Access Compliance Report

Public Rights-of-Way

(Curb Ramps)

Intersection ID: 13786	Main Street: E_7TH_ST	Cross Street: LAMAR_AV	Location:	N
ADA ID: D4DE672355BC	Ramp Type: BlendTrans1	Initial Pass/Fail: Pass	Overall Compliance: No	Severity Score: 30
Codes/Mitigation Info/Possible Solution		Field Measurements/Component Compliance

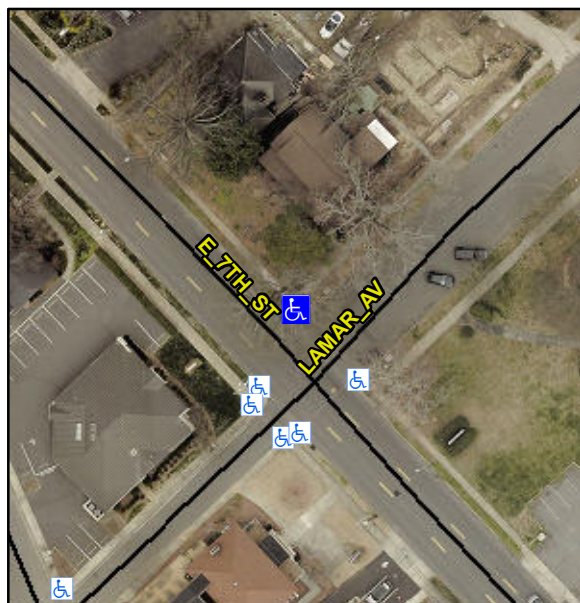
Not Found, R304.2.1, R305, R302.7.2, R304.5.4

Remove & Replace Curb Ramp With Two New Directional Ramps or Equivalent. Remove & Replace Gutter.
